ADDENDUM NO. 1 TO PROJECT NO. Q1665

**CONSTRUCTION WORK
REHABILITATE ROADWAYS AND WALKWAYS
BROOKWOOD SECURE CENTER
PO BOX 419 COUNTY ROAD 29
CLAVERACK, NY**

October 16, 2017

1 REMOVALS & EROSION & SEDIMENT CONTROL PLAN
C-202 / SCALE 1" = 60'

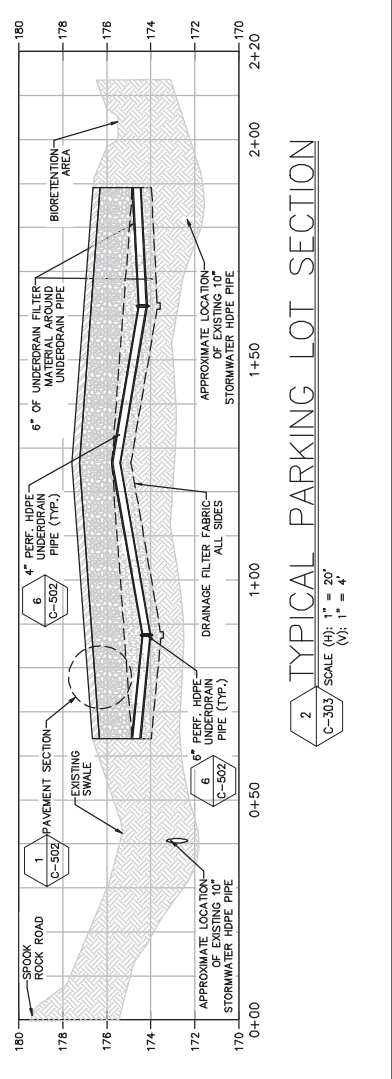
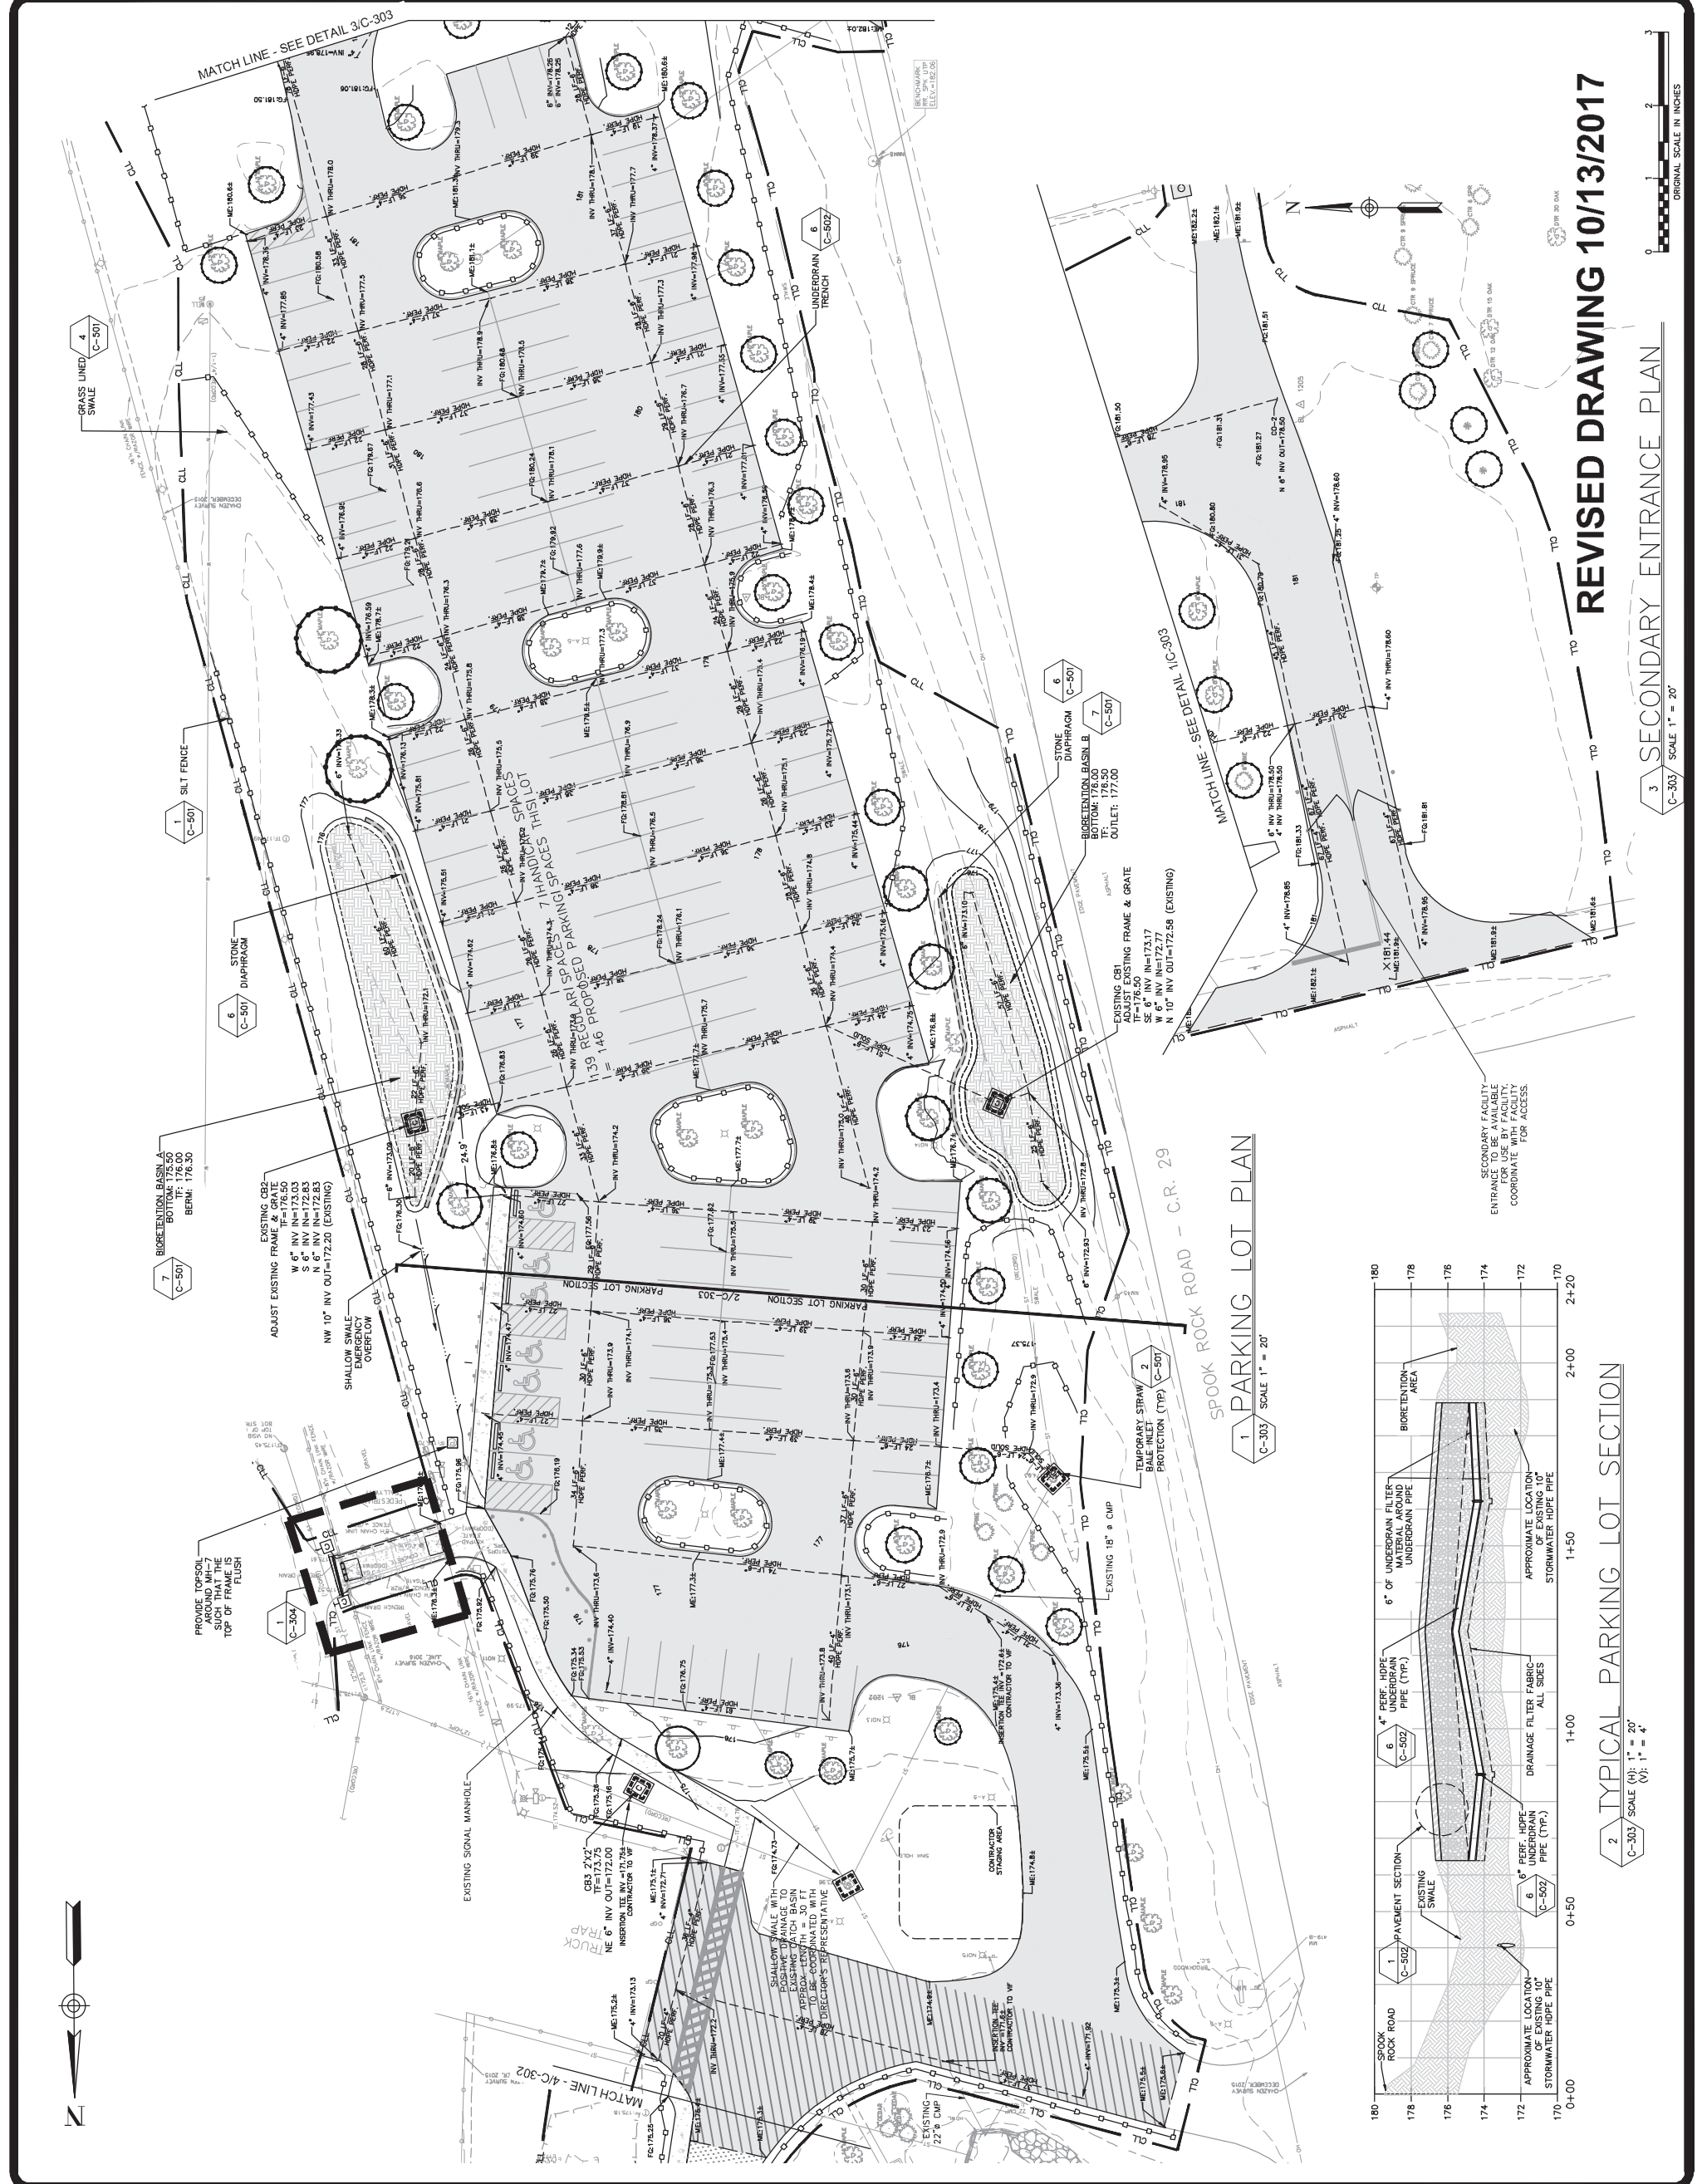
3. Drawing No. G-002, GENERAL SECURITY NOTES, Note 6: Delete this Note in its entirety.
4. Drawing No. G-002, GENERAL CONSTRUCTION NOTES: Add the following Note:
"18. Contractor to assume that electrical conduits associated with parking lot site lighting will be in conflict with the proposed work. The Contractor shall verify the locations and protect existing lighting conduit and appurtenances."
5. Revised Drawings:
 - a. Drawing Nos. C-202, C-302, and C-303 noted "REVISED DRAWING 10/13/2017" accompany this Addendum and supersede the same numbered originally issued drawings.
